30 January 2024

Our ref: 23SUT6785

**RE: Bushfire Advice - Bradfield City Centre Stage 2A Review of Environmental Factors and Roads**

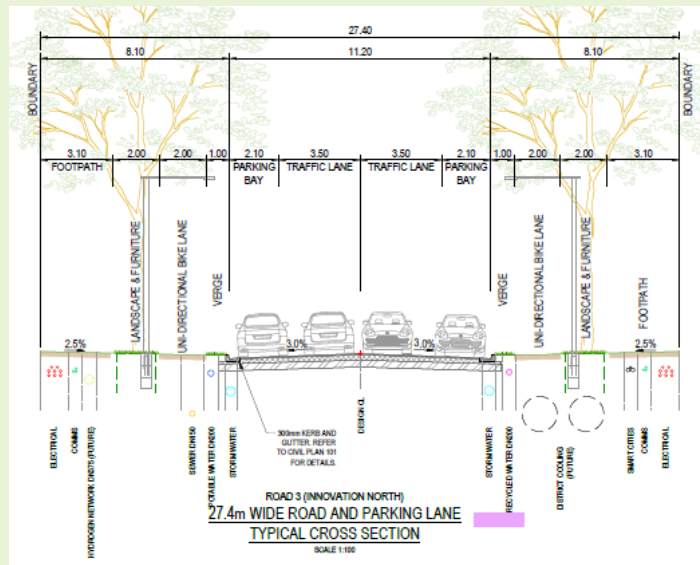
PBP Perimeter Road Requirements	Cross section	Comment
Perimeter roads (Specification as per Table 5.3b of PBP, see Appendix A)		
<b>Road 01</b> <b>(Innovation East)</b> 8 m carriageway requirement	 <p>The diagram shows a typical cross-section of Road 01 (Innovation East), a 39.4m wide road. It features a four-lane dual carriageway with two traffic lanes in each direction, separated by a central median. On either side of the traffic lanes are turn lanes with flex zones. The road is flanked by footpaths and includes various zones such as planting, kerb-only, and 100m kerb and better vision to drive plan 101. The diagram also shows a 3.0% grade and a 3.0% crossfall. The total width of the road is 39.4m, and the scale is 1:100.</p>	<p><b>Requirement(s):</b> The primary acceptable solution specifications for a perimeter road is (see Appendix A):</p> <ul style="list-style-type: none"><li>• Two-way</li><li>• 8 m kerb to kerb carriageway width</li><li>• Parking outside of the carriageway width.</li><li>• Minimum vertical clearance of 4 m</li><li>• Specific requirements also apply for grade, crossfall and other aspects as detailed in Table 5.3b of PBP (see Appendix A).</li></ul> <p><b>Observation:</b> This design currently presents a variation from the acceptable solutions as detailed in Table 5.3b of PBP.</p> <p><b>Comment:</b> The road corridor offers a four-lane dual carriageway with additional provision of a footpath and bike path. The design has merit to meet the intent of the performance criteria for perimeter roads subject to provision of parking and hydrants outside of the carriageway, and/or no parking signage incorporation into the design.</p> <p><b>Recommendation:</b> Discuss and secure concurrence with RFS for a performance solution.</p>

PBP Perimeter Road Requirements	Cross section	Comment
<b>Road 05</b> <b>(Centre Loop South)</b> 8 m carriageway requirement	<p>ROAD 5 (CENTRE LOOP SOUTH)            30.0m WIDE ROAD AND PARKING LANE            TYPICAL CROSS SECTION            SCALE 1:50</p>	<p><b>Requirement(s):</b> The primary acceptable solution specifications for a perimeter road is (see Appendix A):</p> <ul style="list-style-type: none"> <li>• Two-way</li> <li>• 8 m kerb to kerb carriageway width</li> <li>• Parking outside of the carriageway width.</li> <li>• Minimum vertical clearance of 4 m</li> <li>• Specific requirements also apply for grade, crossfall and other aspects as detailed in Table 5.3b of PBP (see Appendix A).</li> </ul> <p><b>Observation:</b> This design currently presents a variation from the acceptable solutions as detailed in Table 5.3b of PBP.</p> <p><b>Comment:</b> The road corridor offers a two-lane dual carriageway, each lane 3.5 m wide with a 3 m parking bay.</p> <p><b>Recommendation:</b> It is recommended the Road 05 design is amended to utilise a 2.5 m parking bay and 4 m one-way carriageway. While a 4 m one-way carriage way is still considered a performance solution under PBP, it can meet the intent of the prescribed 8 m two-way carriageway. Discuss and secure concurrence with RFS for a performance solution.</p>

PBP Perimeter Road Requirements	Cross section	Comment
<p><b>Road 06</b></p> <p><b>(Centre Loop West)</b></p> <p>8 m carriageway requirement</p>		<p><b>Requirement(s):</b> The primary acceptable solution specifications for a perimeter road is (see Appendix A):</p> <ul style="list-style-type: none"> <li>• Two-way</li> <li>• 8 m kerb to kerb carriageway width</li> <li>• Parking outside of the carriageway width.</li> <li>• Minimum vertical clearance of 4 m</li> <li>• Specific requirements also apply for grade, crossfall and other aspects as detailed in Table 5.3b of PBP (see Appendix A).</li> </ul> <p><b>Observation:</b> This design currently presents a variation from the acceptable solutions as detailed in Table 5.3b of PBP.</p> <p><b>Comment:</b> The road corridor offers a two-lane dual carriageway, each lane 3.5 m wide with a 3 m parking bay.</p> <p><b>Recommendation:</b> It is recommended the Road 06 design is amended to utilise a 2.5 m parking bay and 4 m one-way carriageway. While a 4 m one-way carriage way is still considered a performance solution under PBP, it can meet the intent of the prescribed 8 m two-way carriageway. Discuss and secure concurrence with RFS for a performance solution.</p>

- Consultation and secured concurrence with RFS should be sought for performance solutions for all three perimeter roads.
- Road 01: Parking and hydrants to be located outside of the carriageway. Given current plans indicate no parking along this road, no parking signage must be incorporated into the design.
- Road 05 & 06: Design amendment to utilise a 2.5 m parking bay and 4 m one-way carriageway.
- Or alternate design specifications developed in conjunction with a bushfire consultant and RFS.

**Road 03**  
**(Innovation North)**  
 5.5 m carriageway requirement

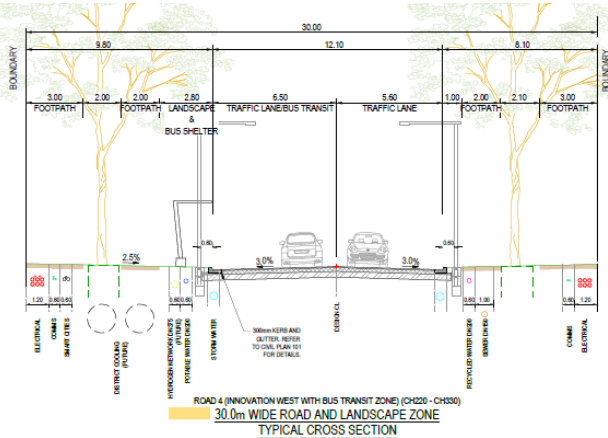
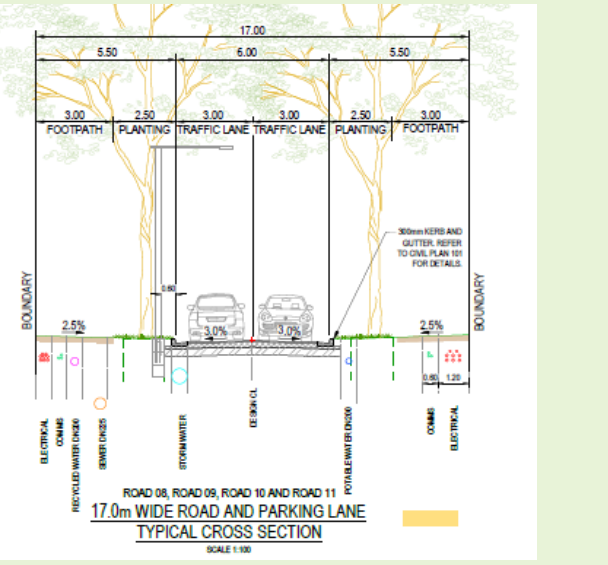
Road width dimensions comply with non-perimeter road access requirements, being a minimum of 5.5 m two-way carriageway width with designated parking outside of this area.  
 Refer to Table 5.3b of PBP for full specification.
